Subject: Notification of Planned Physical Alteration to the Permitted Facility, Hazardous Waste Facility Permit, Number: NM4890139088-TSDF

The purpose of this letter is to notify you of a planned physical alteration to the permitted facility in accordance with Permit Part 1, Section 1.7.11. (20.4.1.900 New Mexico Administrative Code (NMAC) incorporating Title 40 of the Code of Federal Regulations (CFR) §270.30(l)(1)). The U.S. Department of Energy (DOE) and Nuclear Waste Partnership LLC (NWP), collectively referred to as the Permittees, intend to augment the facility system known as the underground ventilation system (UVS) with the Interim Ventilation System (IVS). The UVS is broadly described in Permit Attachment A2, Section A2-2a(3).

**Augmentation to HEPA Ventilation
(Draft Concept Drawing Only)**

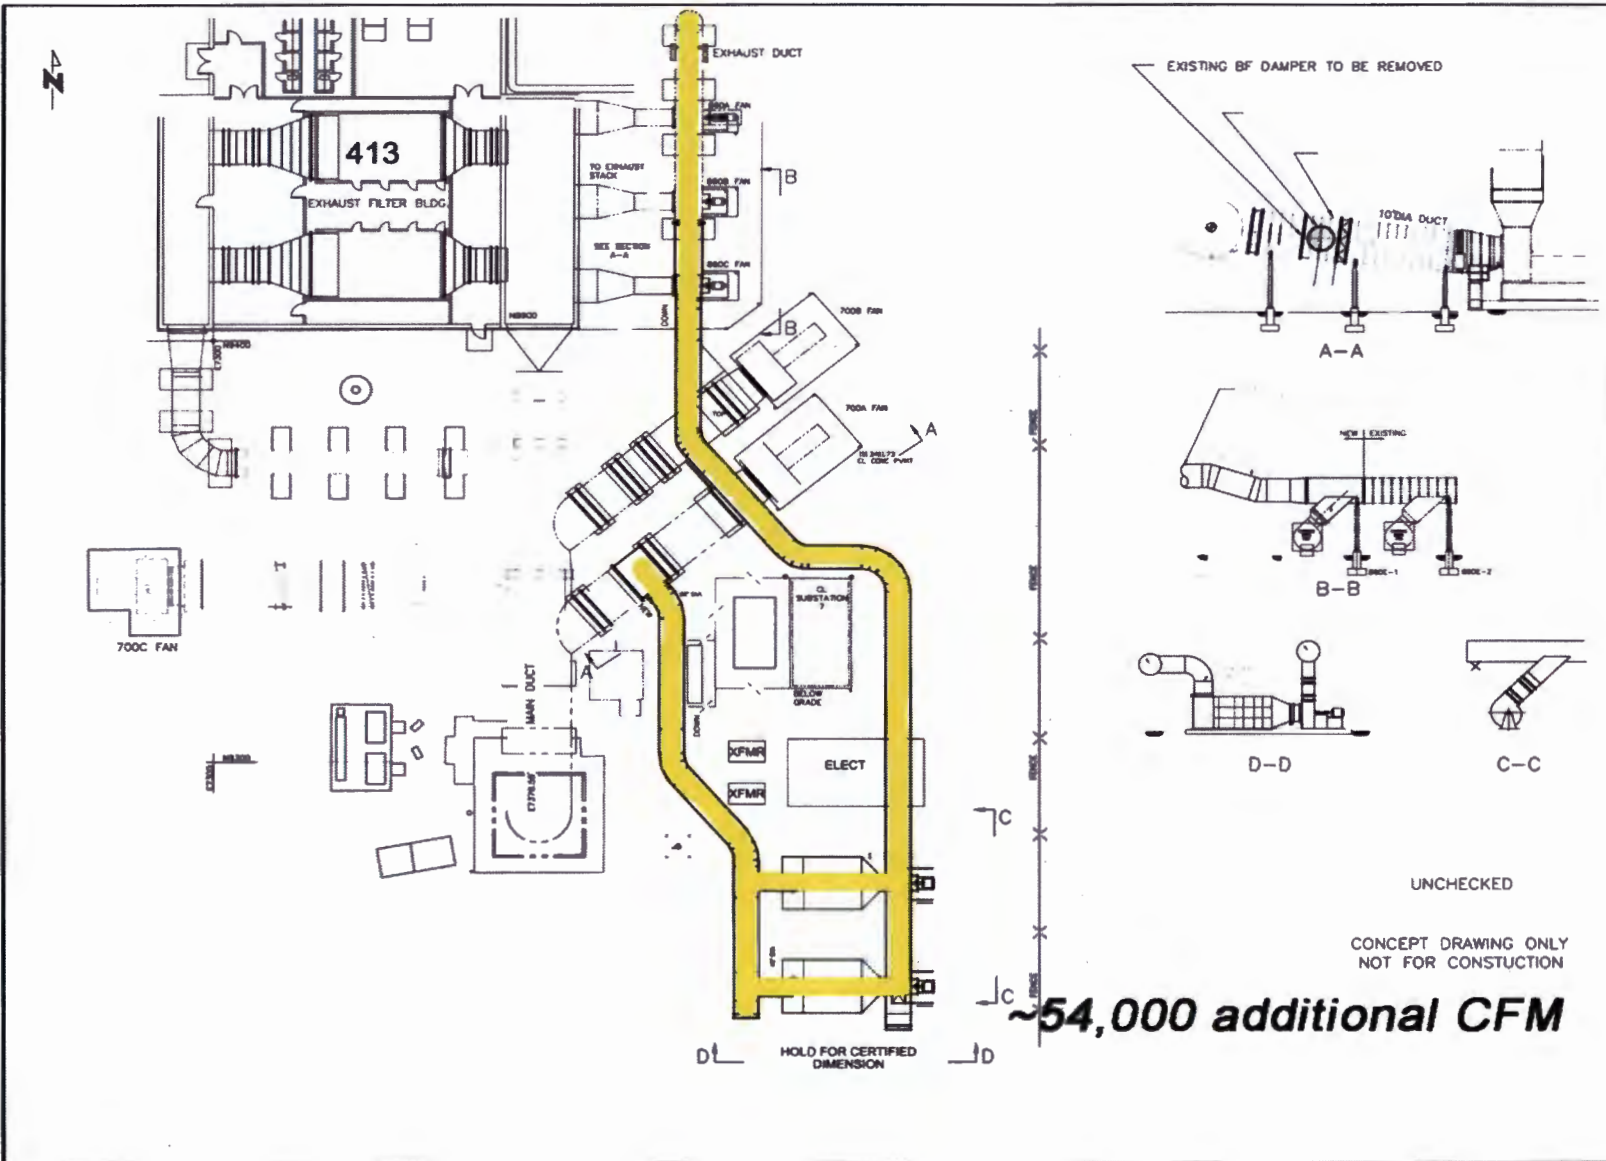
The IVS consists of two skid mounted fan and filter units that will be added to the UVS in order to increase the current filtration capacity of the UVS. The current filtration capacity is 60,000 cubic feet per minute (cfm). The primary functions of the augmented ventilation system will be to remove the airborne radioactive particulate from the exhaust air through high efficiency particulate air (HEPA) filtration before the air is released to the environment and to provide additional ventilation air flow in order to achieve up to 114,000 cfm in filtration mode. A draft conceptual drawing of the augmented ventilation system is attached for information.

~54,000 additional CFM
